PARK  $\mathbf{O}$ S SITE DEVELOPMENT PLAN LOT 2 CLAREMONT BUSINES FILING NO. 2 QUALITY BRAND GROUP CO, S 80

## LANDSCAPE PLAN

File number: PPR2345 REVISED; information added

NTRACTOR IS REQUIRED TO CONTACT THE COUNTY PUBLIC WORKS DEPARTMENT, AND ANY OTHER PUBLIC OR PRIVATE AGENCY NECESSARY FOR RIOR TO ANY CONSTRUCTION.

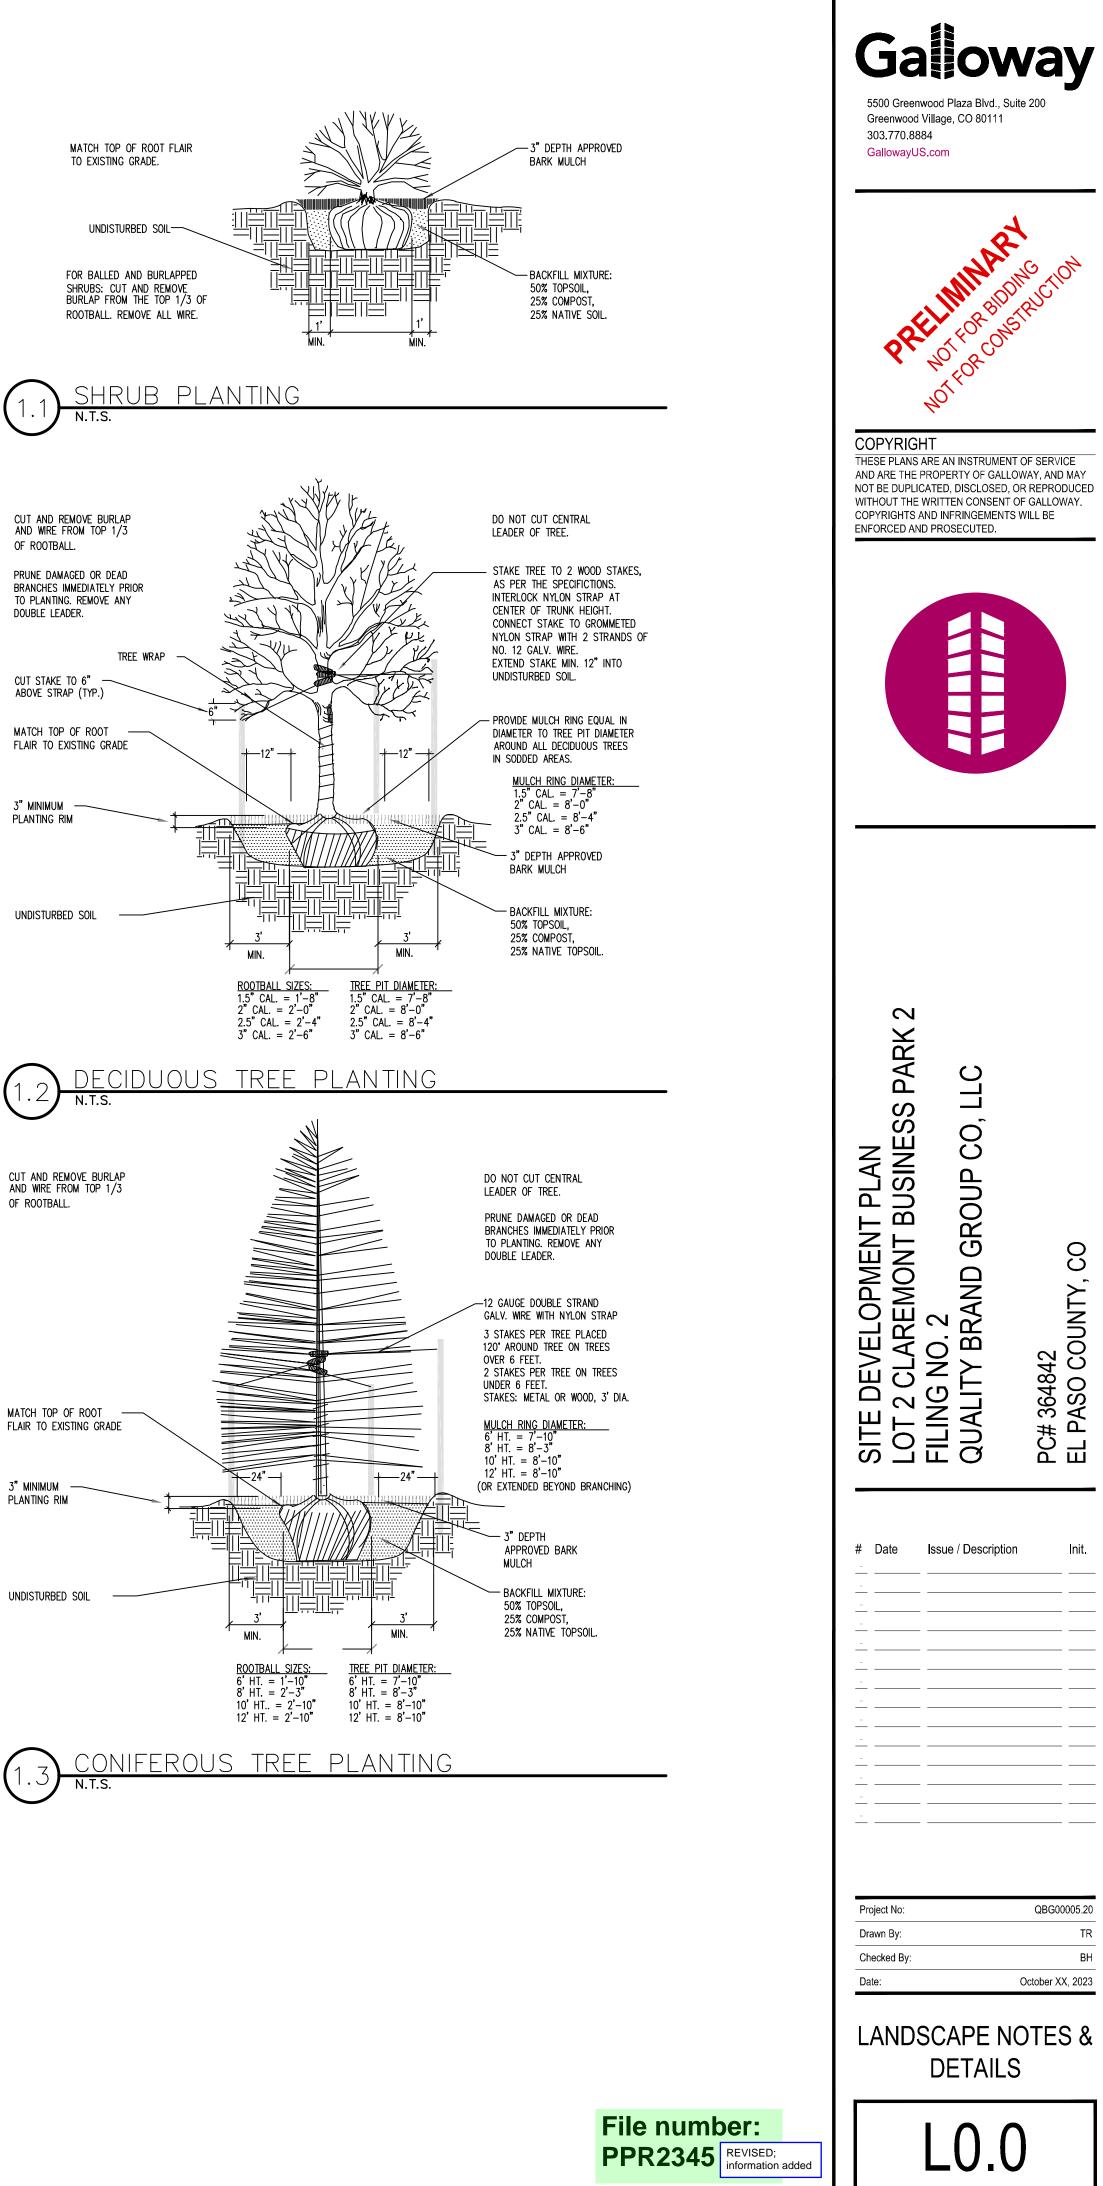
EMAIL: GEORGIANNE2@MSCIVIL.COM	-lot size information added	
		<b>O</b>
PLANTING NOTES		
1. ALL WORK SHALL CONFORM TO ALL APPLICAE	BLE STATE AND LOCAL CODES, STANDARDS, AND SPECIFICATIONS. URE. THE CONTRACTOR SHALL BE RESPONSIBLE FOR HIS OWN TAKEOFFS AND QUANTITY CALCULATIONS. IN THE EVENT OF A	S
DISCREPANCY BETWEEN THE PLAN AND THE L OF THESE DISCREPANCIES. MINOR ADJUSTME	LANDSCAPE LEGEND, THE PLANT QUANTITY AS SHOWN ON THE PLAN SHALL TAKE PRECEDENCE AND NOTIFY THE LANDSCAPE ARCHITECT INTS TO THE LANDSCAPE MATERIAL AND LOCATIONS MAY BE PROPOSED FOR CITY CONSIDERATION AT THE CONSTRUCTION DOCUMENT	ć:3
	conditions. However, there shall be no reduction in the number and size of materials. If the locations of existing and proposed utilities, and shall be responsible for any damage to the utilities and/or any	张
INJURY TO ANY PERSON. THIS DRAWING IS	PART OF A COMPLETE SET OF CONTRACT DOCUMENTS. UNDER NO CIRCUMSTANCES SHOULD THIS PLAN BE USED FOR CONSTRUCTION TIONS OF UTILITIES ON SITE AND REVIEW ALL RELATED PLANS AND DOCUMENTS.	Ê

REVISED; information added information added REVISED; information added
